CITY PLANNING COMMISSION

APPLICATION: Variance to allow the street side yard setback to be reduced from the required 5 feet to 0 feet.

LOCATION: 725 14th Street

PROPOSAL: The applicant is requesting the necessary entitlements to expand an existing athletic club with a 2 story addition in order to add an aerobics room and expand the men's locker room.

EXHIBIT A

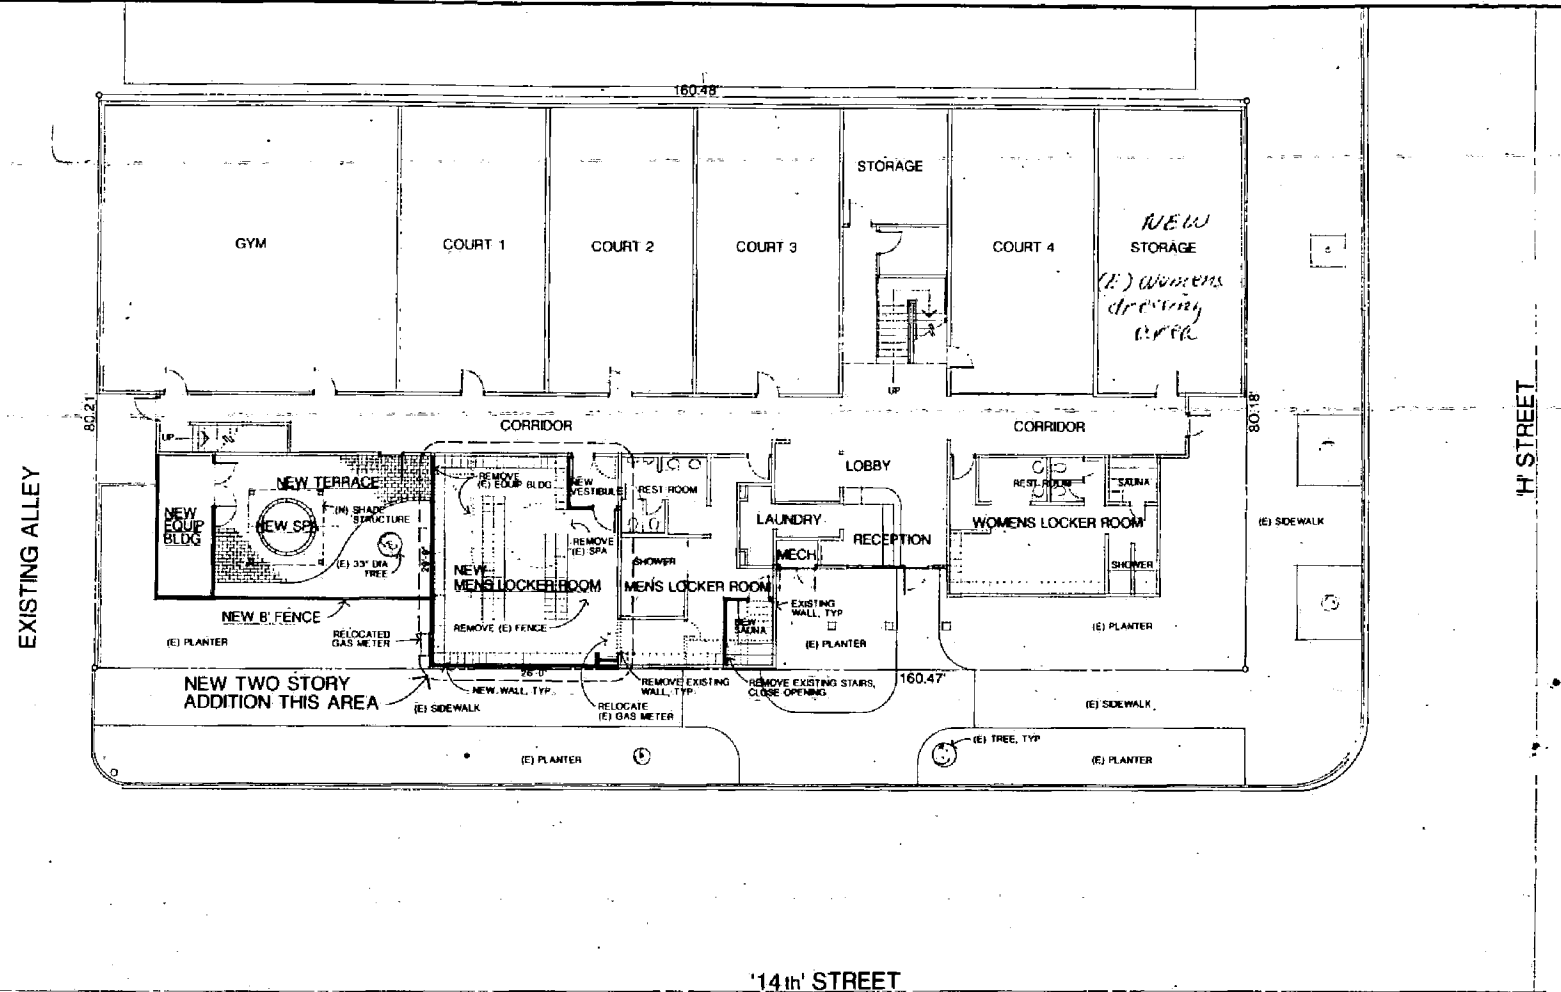
As shown in Exhibit A, Site Plan/First Floor Plan, the addition would provide a new aerobics room on the upper level, and enlarge the men's locker room. The men's locker room would also be more functional because it would be located on the lower level, versus two levels as it is now.

The north elevation of the addition would be located 4' from an existing large avocado tree shown on the site plan to be 33 inches in diameter. The City arborist has inspected the site and has indicated the following:

The tree is an attribute worth protecting. Because of its location, design possibilities are limited that would provide the square footage desired and stay within the 5' side yard setback. Due to this hardship, staff is not opposed to the variance request with the condition that the design review concerns indicated by the Design Review Director are met. These concerns are as follows:

1. The encroachment shall be 4' instead of 5' in order to provide a 1' wide landscape planter at the base of the addition between the property line and the wall.
2. The planter shall be planted with climbing vines that will grow along the face of the wall in order to soften the wall mass.

1. The area of encroachment shall be reduced from the proposed 5 feet to 4 feet. A one foot wide landscape planter shall be provided between the west property line and the west elevation of the addition.

2. The one foot wide planter shall be planted with four one gallon size plants which shall be Boston Ivy, or other comparable climbing vine, approved by the City's landscape architect. A ground cover "Hypericum", or other comparable ground cover, shall also be provided in the planter area in the amount and form specified by the City's landscape architect. The planter shall be irrigated.
3. All conditions of the City arborist pertaining to the avocado tree shall be met. Any modifications to the large avocado tree shall be approved and modifications done, only in the presence of the City arborist.
4. The project shall be reviewed and approved by the Design Review Board prior to issuance of building permit.
5. A landscape and irrigation plan for the required one foot wide planter area shall be submitted to the Planning Director prior to the issuance of building permits.

WEST ELEVATION

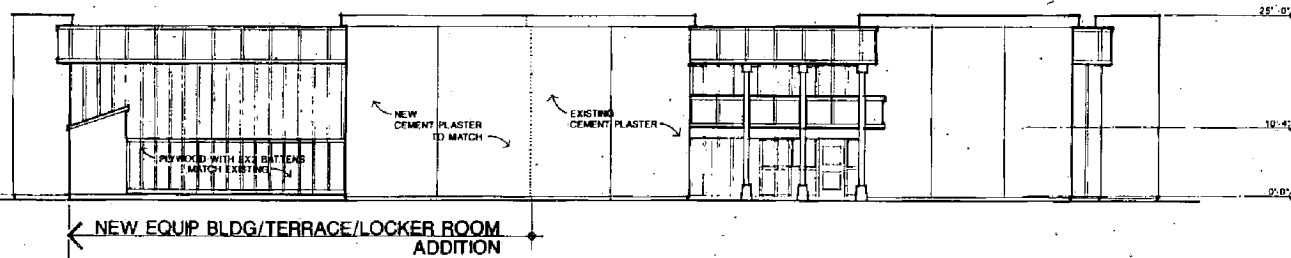
For information purposes, approximately 40 percent of the west elevation wall would be located on the west property line with the proposed project, and the remaining 60 percent of existing wall area has varying setbacks of 9.5', 14', and 38 feet. The total length of the west elevation wall is 160.48'; of this length, a 22' wide section of the wall sits on the west property line (the lot was previously zoned C-3). This 22' wide section of wall on the property line would be increased to 48' with the addition.
